Agenda Item Number: <u>B 296-15</u> Department Source: Community Development - Planning To: City Council From: City Manager & Staff Council Meeting Date: 10/19/2015 Re: Barcus Ridge Plat No. 2 & variance to Section 25-53(4) (Case #15-202)

AGENDA REPORT PLANNING AND ZONING COMMISSION MEETING October 8, 2015

A request by Crockett Engineering (agent) on behalf of Tompkins Homes and Development (owner) for approval of a five (5) lot final plat to be known as "Barcus Ridge Plat No.2" and a variance to Section 25-53(4) relating to residential driveway access on Old Plank Road. The approximate 21.80 acre site is located on the north side of Old Plank Road southwest of Route K and Old Plank Road. **(Case #15-202)**.

15-202: Barcus Ridge Plat No. 2 Final Plat

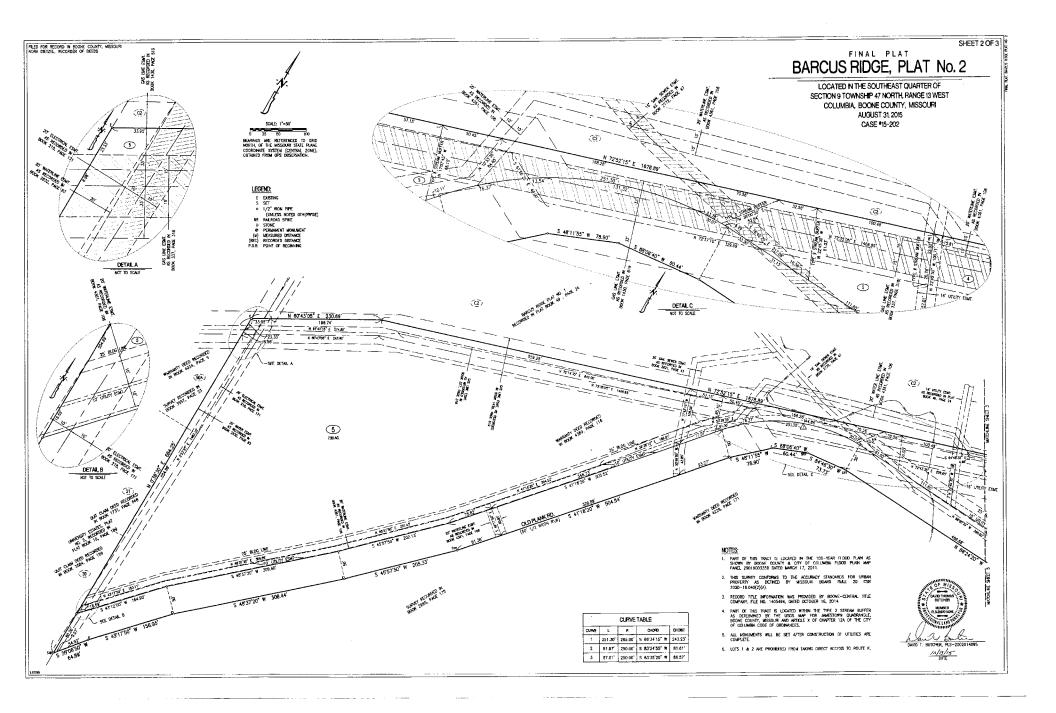
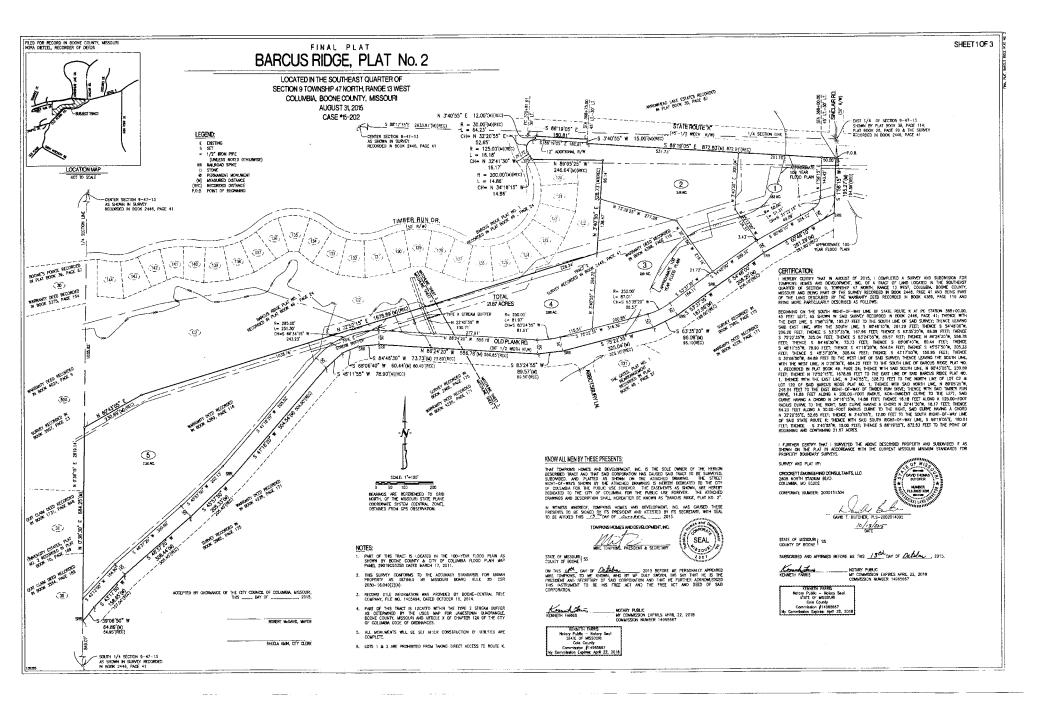
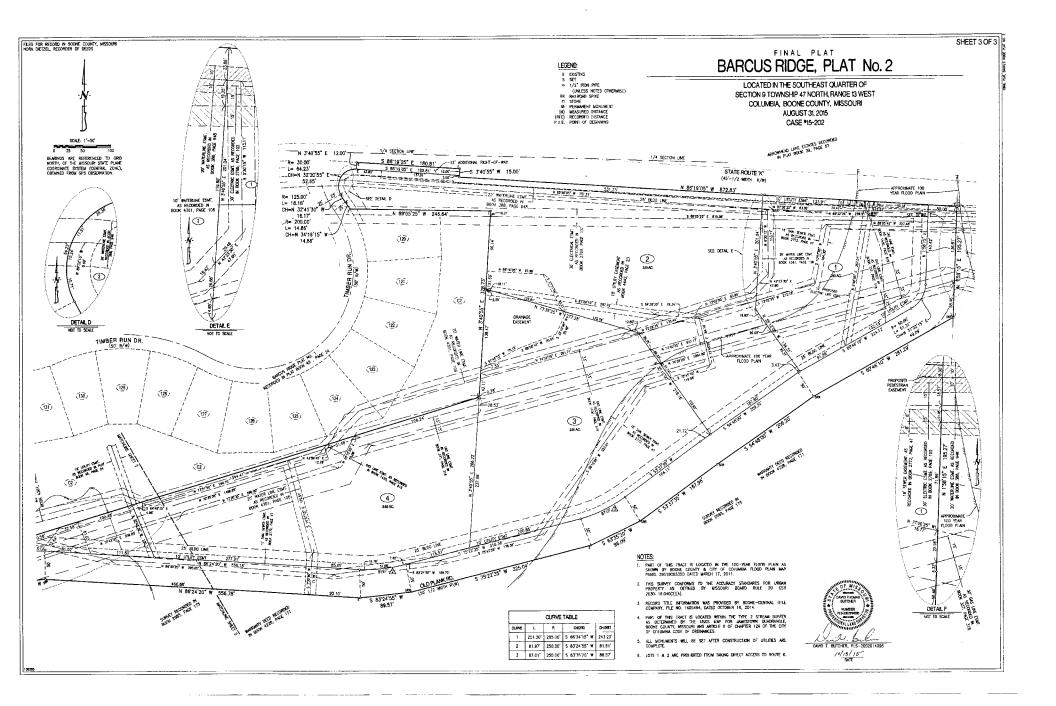
MR. ZENNER: Lots 3 and 4 would have driveway locations as defined on the road profile. The topography associated with Lots 3 and 4, as you see here on the plat, are relatively restricted. Therefore, the driveway locations that the applicants engineer has provided to us are pretty much where those driveways would have to go in order to get a buildable lot. One of the things that our traffic engineers would like to be able to determine with the engineering -- applicant's engineer is that the sight distances are verified so when the roadway is improved, i.e., being widened in the future, the driveway locations in the current state with a two-lane roadway section and then in the future state with normally a three- to four-lane section will not be compromised, the vision -- the sight triangles coming from those driveways. They may need to be shifted at this point, but it would be a single drive to 3, 4, a common private roadway serving Lot 5, and then a shared driveway access in actuality is shown on the O-P plan, which is what Lot 1 is proposed to be rezoned to is actually the majority of that driveway is on Lot 1, comes up the property line and then comes into the -- the proposed parking area for the office building and would come across into Lot 2 as a driveway connection in essence. So we're looking at in -- a commercial driveway connection at Lot 1, Lot 2, two driveways which would probably be anywhere between ten to twelve feet wide, and then generally a 28-foot-wide private road coming off into Lot 5.

MS. RUSHING: In this area, the -- the roadway is very curvy, and I have significant concerns about having all of those drives entering onto a road that curves around and would appear that would have limited sight as far as the distance and speed that people are traveling along that roadway.

Approval of the 5-lot plat and variance to Section 25-53(4) subject to final approval of the roadway profile and verification of sight distances from each driveway access being met.

MR. ZENNER: That is correct, and that is what the condition of approval is predicated on.
